RAI Volume 2, Chapter 2.1.1.4, Ninth Set, Number 2:

Subject: Generation of seismic fragility curves for ITS buildings.

Figure 1. Surface Facilities Area Horizontal Mean Hazard Curve for Peak Ground Acceleration

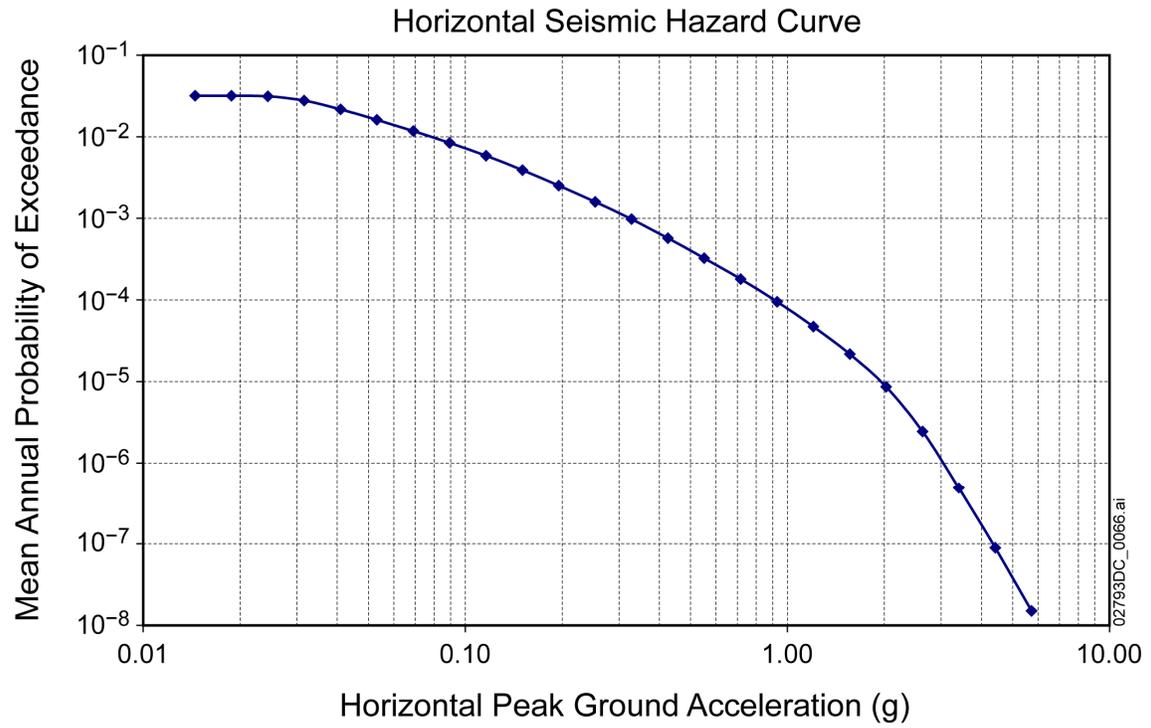
An example is presented to illustrate the variation in the computed P_F as a function of $\beta_c = 0.3, 0.4, 0.5,$ and 0.6 . For this example, the surface facilities area horizontal mean hazard curve for peak ground acceleration shown in Figure 1 and tabulated in Table 5 is used. The $C_{1\%}$ capacity for the Canister Receipt and Closure Facility (CRCF) is used. For the CRCF, $C_{1\%} = 1.82$ g. For $\beta_c = 0.3, 0.4, 0.5,$ and 0.6 , Table 6 presents the computed median capacity $C_{50\%}$, the total annual failure probability P_F , the failure probability $\Delta P_{F1\%}$ associated with ground motion less than $C_{1\%}$, and the failure probability $\Delta P_{F50\%}$ associated with ground motion greater than $C_{50\%}$. The following observations can be made from the results shown in Table 6:

Although these specific reported fractile ΔP_F results are specific to the hazard curve shape shown in Figure 1 and to the location of $C_{1\%} = 1.82$ g on this hazard curve, the trend of results is consistent with results obtained from many other convolutions of hazard curves and fragility curves.
